# UNITED STATES PATENT AND TRADEMARK OFFICE

APPLICATION NO.	FILING DATE	FIRST NAMED INVENTOR	ATTORNEY DOCKET NO.	CONFIRMATION NO.
10/018,369	12/19/2001	Hideaki Ito	740819-715	4540

<b>Office Action Summary</b>	Application No.	Applicant(s)	
	10/018,369	ITO ET AL.	
	Examiner	Art Unit	
	John Hoffmann	1731

## DETAILED ACTION

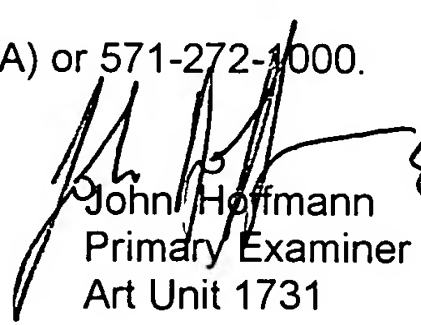
In the 18 November 2005 response Applicant argued that figures 4 and 5 implicitly provide support for the limitations. The arguments are made again in the 5/1/06 response. Examiner disagrees for the following reasons:

1) Applicant asserts equations to show what the ratio of cross sectional ratios are. But no evidence/derivation is provided to show that the equations are proper or reasonable.

2) When Examiner utilizes the equations, he arrives negative values that are orders of magnitude greater than those contained in the table of page 8 of the 18 November response.

3) When Examiner calculates the actual cross-sectional areas, Examiner finds the ratios to be the identical (within rounding error).

4) Contrary to Applicant's assertion, Examiner does not appreciate that the two equations \*will\* be equal when the feed rates are equal, etc. Applicant suggests that the  $d_1$  and  $D_1$  measurements (equation 2) represents the ratio of areas of the unified rod/pipe. The  $d_1$  and  $D_1$  measurements occur mid-process – Examiner thinks it might be possible that the pipe or the rod might be stretched at different rates after the  $d_1/D_1$  location. The  $d_2$  and  $D_2$  measurements represent unchanging diameters of the unified rod/pipe which could be used to determine the relative output rates accurately.

5) When using  $d_2$  and  $D_2$  Examiner again finds that the ratios are the same – and thus the feed rates are the same.

For these reasons it is deemed that Applicant has failed to provide a prima facie showing of implicit support for the invention as now claimed.
